Subject: 60 vermont drive

EP/131/18/DOC
EP/132/18/DOC
WP147/18/DOC

With reference to the three new Planning Applications dated October 2018 reference Nos EP131/18/DOC, EP132/18/DOC and EP147/18/DOC

To complete the work, then I agree that the existing garage had to be removed. I enclose my hand drawn sketch detailing my alternative plan as follows

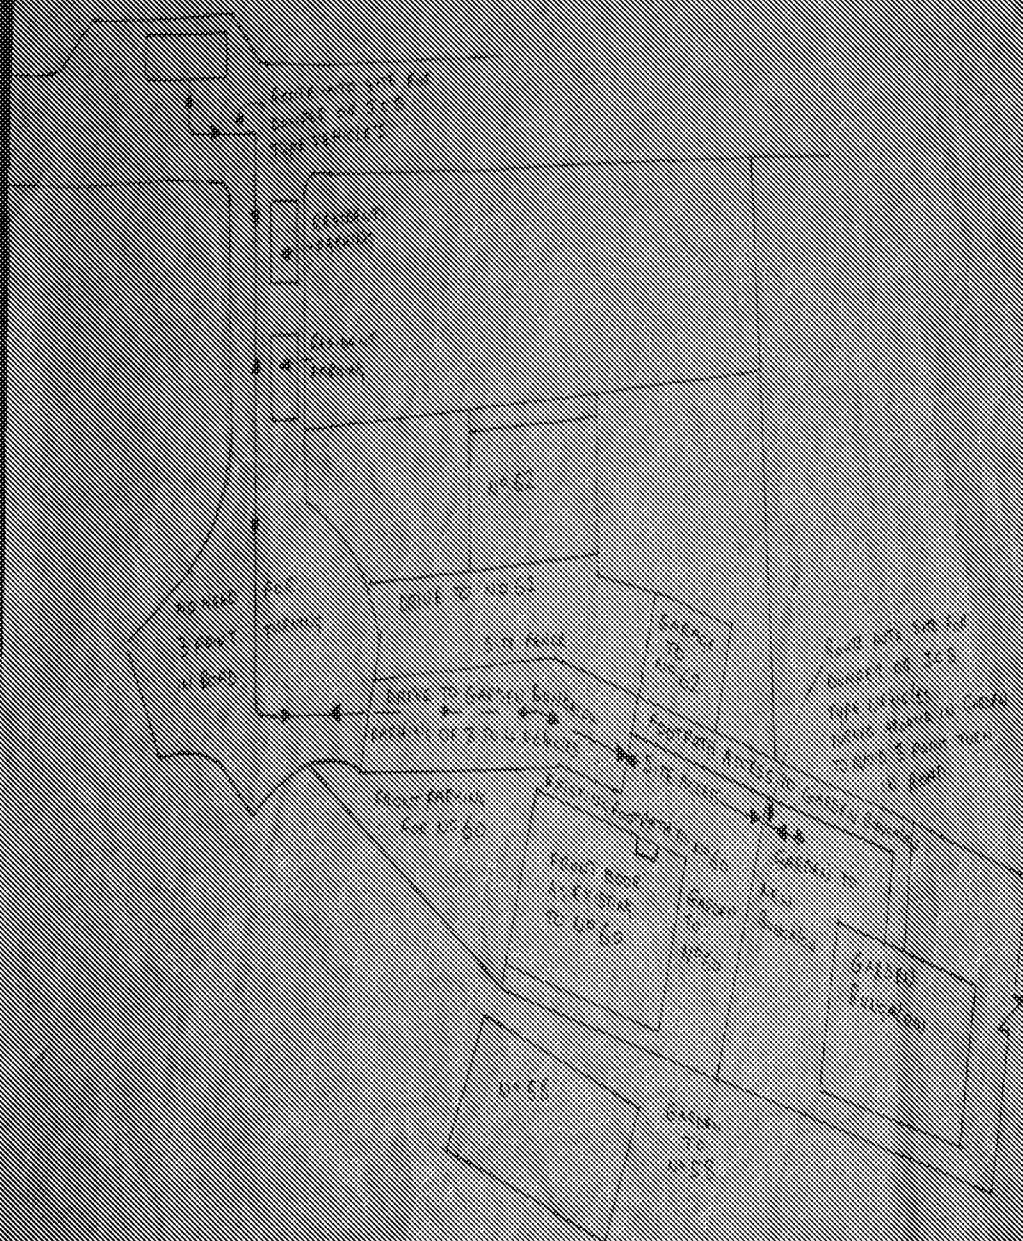
2] With regard to the ongoing situation once the new property is completed. There would now be vehicles travelling along the new 40 metre section of driveway to and from the new rear garden property. To the blind dogleg section of driveway there could be an incident between a motor vehicle and a resident/pedestrian from the adjoining properties. This could result in injury or a fatality

My plan would have been to include for only a footpath instead of a new drive, this would also remove the need for a turning point and parking spaces. The drive would stop as it is at present on a line with the remaining adjoining garage to No 62 Vermont Drive. A fence or wall should be erected with a gated access to the rear garden property. From this point the new garden property would have been accessed only by this footpath.

Parking would still be available on the drive for three vehicles, no different to the present situation. This would address concerns with the Health and Safety of residents being on the drive as the situation would be no different to that as it is at present. This would eliminate the blind dog leg section where there is a driveway blind spot. No 60 would be restricted to only one parking space on its remaining drive to the front elevation. The present block paved drive could be altered to allow for a second smaller vehicle on the drive.

This would also remove the pollution and noise, to the adjoining properties to the rear garden but above all the Close would be a lot safer place to live.

The existing bungalow No 60 would not require its structural changes mainly to the repositioning to its front door and associated internal work. And the cost saving relating to the drive to the new property as proposed as a footpath.
